PREFACE (INCLUDING RESPONSES TO COMMENTS)

The City of Riverside (City), through its Community & Economic Development Department, Planning Division (Department), is the lead agency responsible for the review and approval of the proposed Street Light Replacement for Areas 3–5B Project (project or proposed project). The City has made the determination that a mitigated negative declaration (MND) is the appropriate environmental document to be prepared in compliance with the California Environmental Quality Act (CEQA). Similarly, MNDs were prepared and approved for the previous lighting phases of Area 1 (Planning Case P12-0043) and Area 2 (Planning Case P15-0344) in 2012 and 2015, respectively. Based on light complaints from Area 1 of the Wood Streets Street Light Project, the need for tree trimming in some areas, and the potential for sidewalk detours during light replacement activities, mitigation measures were incorporated into the previous Area 2 phase. Similar mitigation measures are proposed for Areas 3–5B of the proposed project to ensure impacts are less than significant.

Street Light Replacement for Areas 3-5B Project

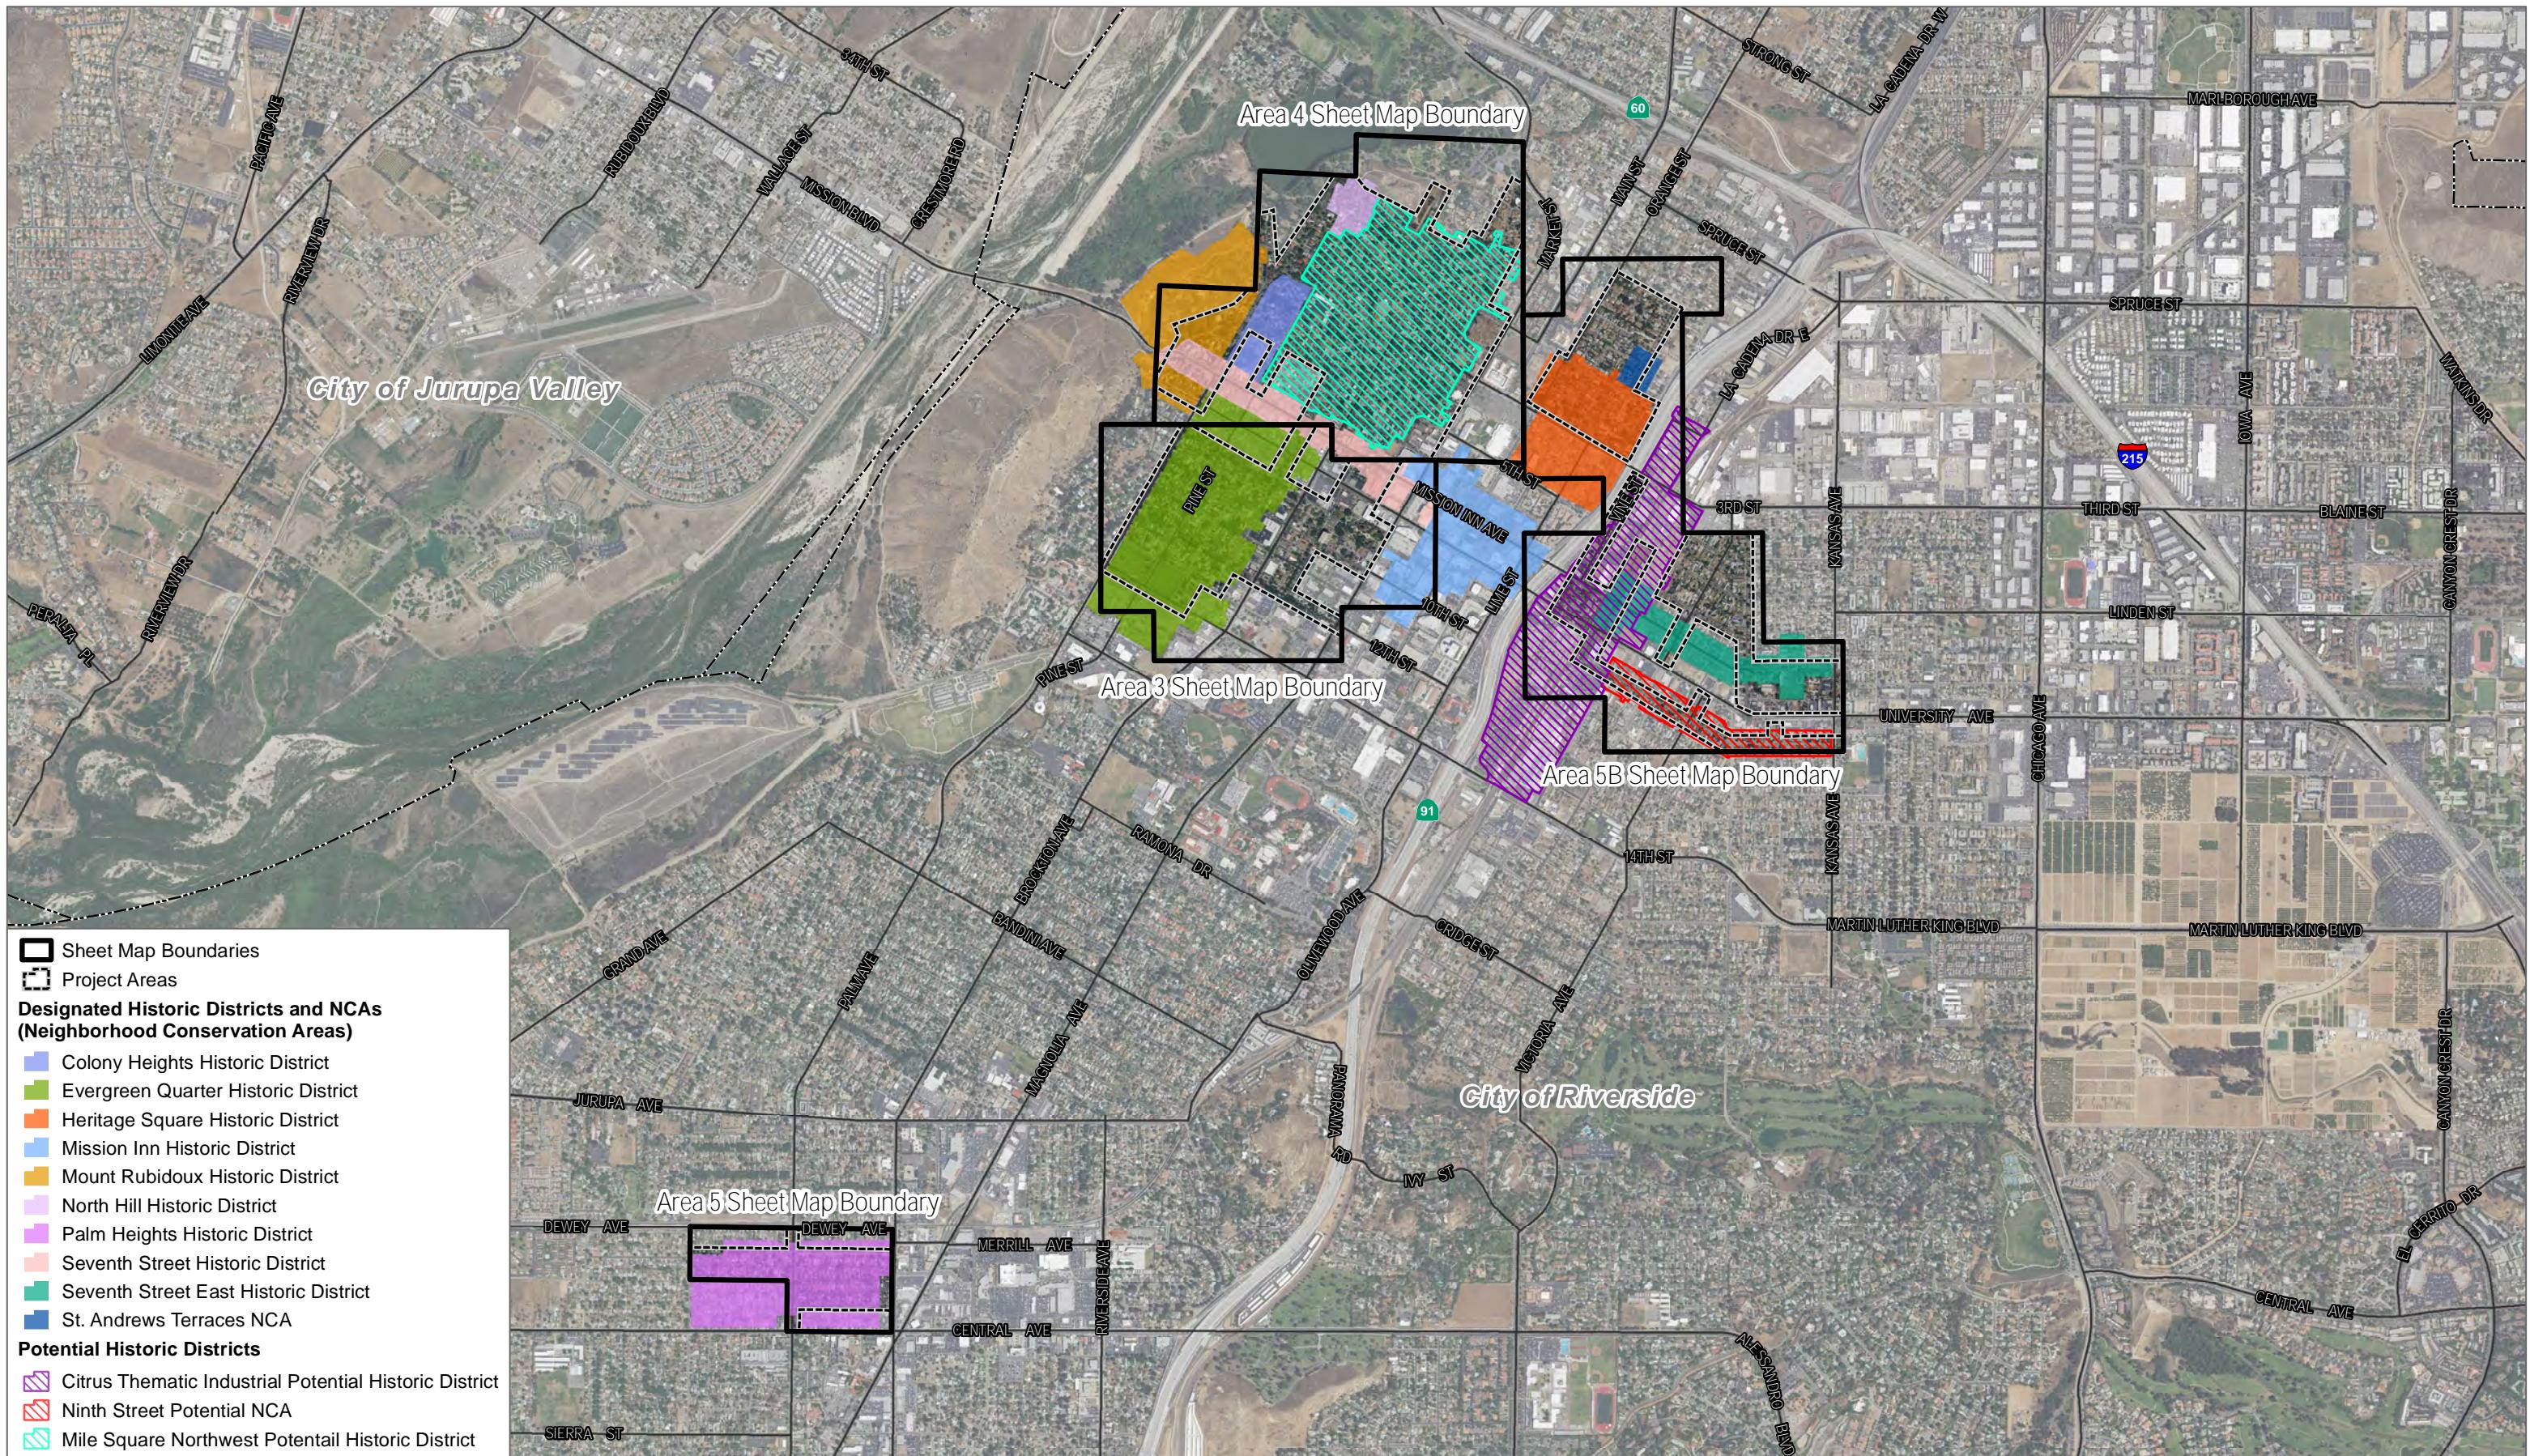
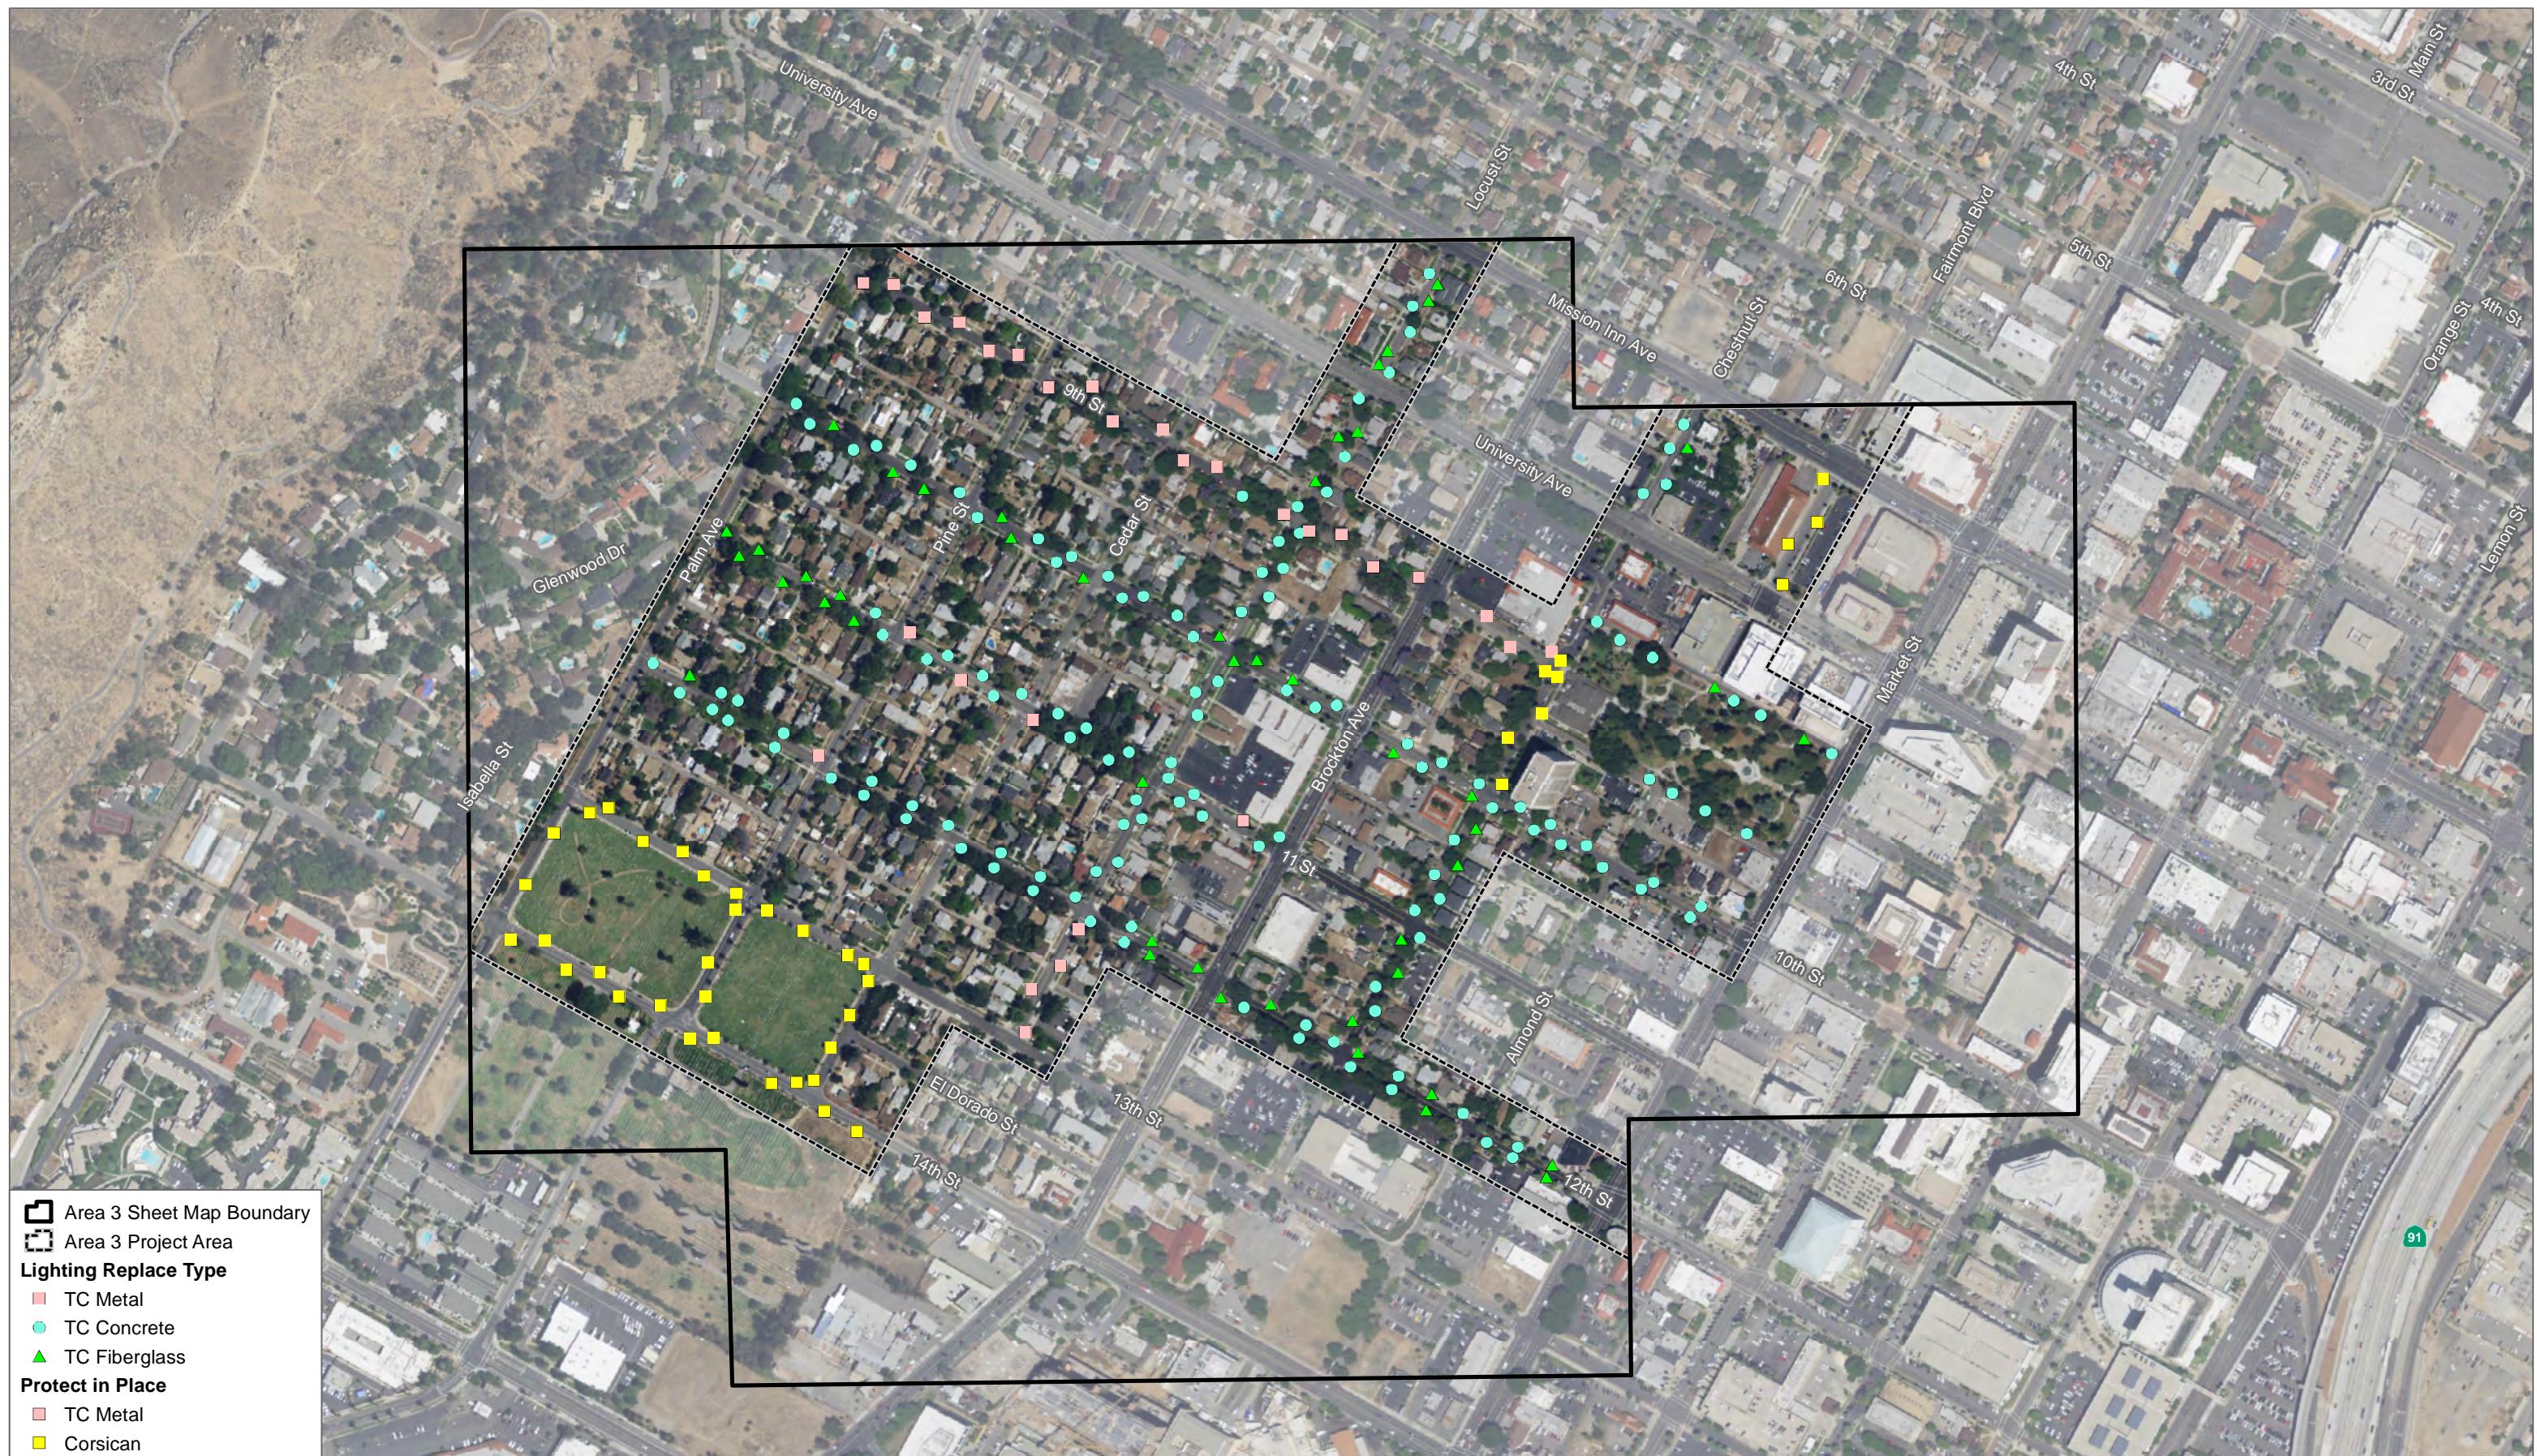
A-1 The commenter expresses concern regarding the height and location of the proposed streetlights, and potential impacts this may have on airplane hazards. Figures 3 through 7, included in the IS/MND, show all locations where the streetlights would be replaced. As discussed in IS/MND Section 4.2.5a, the proposed number and spacing of streetlights is based on American National Standard Practice for Roadway Lighting ANSI/IESNA RP-8 (RP-8), the standard approved by the Riverside City Council in 1996. As advances in lumen output technology have been made since installation of the existing historic streetlights, RP-8 Standards would actually reduce the number of streetlights needed per block to provide required lighting levels. Thus, the proposed project is expected to result in fewer streetlights than currently exist in Areas 3 through 5B. Provisions of the City's historic preservation ordinance, Title 20, the Secretary of the Interior's Standards for the Treatment of Historic Properties related to historic resources and design standards and guidelines, require that replacement streetlights look similar to existing ones. Thus, it is expected that replacement streetlights would be similar in height to existing streetlights. More specifically, the design details of the proposed replacement streetlights, including the proposed height of the streetlights, have been incorporated as Figure P-1, Replica Kodiak Replacement Streetlights Details, and the design details of the proposed luminaires have been included as Figure P-2, Proposed Luminaire Details. As shown in these figures, the standard and luminaire, together, indicate a total installed height of 14 feet and 3.5 inches. It should be noted that the height of the proposed replica streetlights is approximately 2 inches taller than existing streetlights. However, the existing direct embedment historic streetlights currently vary in height for a variety of reasons, such as the depth of the original excavation at the time of installation, soil compaction, minor changes in parkway elevation due to landscaping changes, settlement, and intrusion by tree roots. It should also be noted that although not all the streetlights would be replaced in the exact same location as the existing streetlights, replacements would be made in the same general locations (either adjacent to or across the street from existing streetlights). Further, the proposed streetlights are not expected to exceed the heights of other structures in the areas, including two- to three-story existing structures in the area, telephone poles, palm trees, etc. Lastly, as discussed in Section 4.2.8d, although part of the project site is located within Compatibility Zone "Other Airport Environs" of the Riverside Municipal Airport, only uses that would be hazardous to flight (such as tall structures) are prohibited within this zone.. The City provided additional information regarding the height and location of the proposed streetlights to the commenter on October 3, 2018, and November 1, 2018.

B-1 Based on the information provided by the City, the commenter confirms that the height of the proposed streetlights are below the Federal Aviation Administration's threshold for height obstacle obstruction, and thus no potential issues regarding flight hazards are expected. No further response is required.
